West Sound Utility District

Pump, Motor Replacement and Redevelopment of Well 18

Addendum #1

I. Section 4.3 Cleanout and Redevelopment:

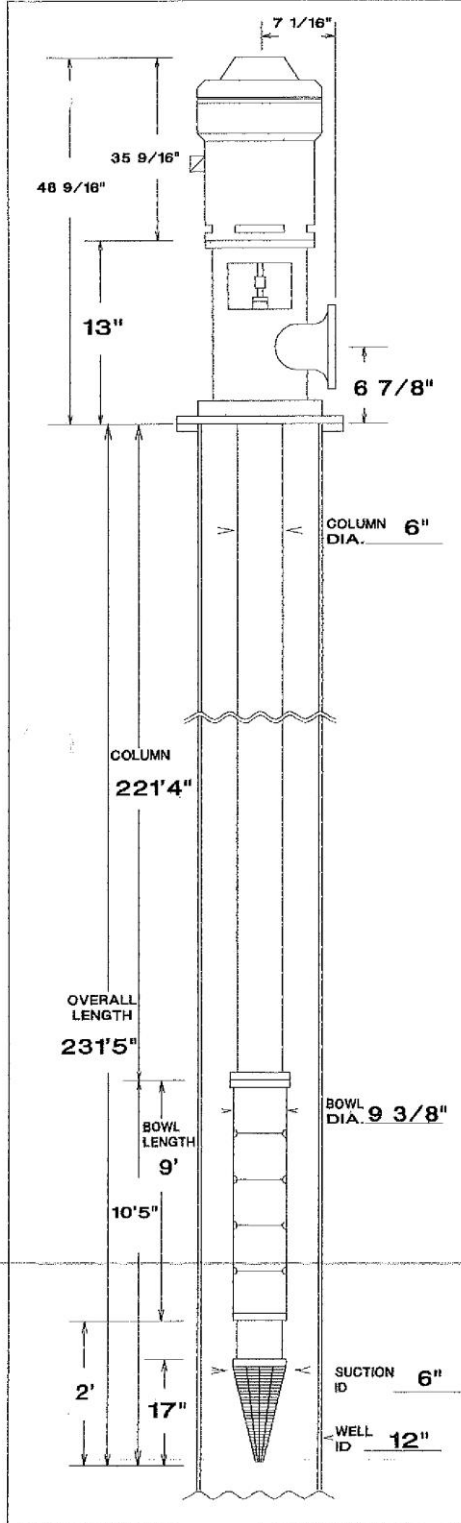
After the video inspection, cleanout shall include the brushing of the interior of the well casing and screens to remove loose scale and encrustation, then bailing any accumulated material (~~above the abandoned tooling~~) from the well with a sand-pump bailer.
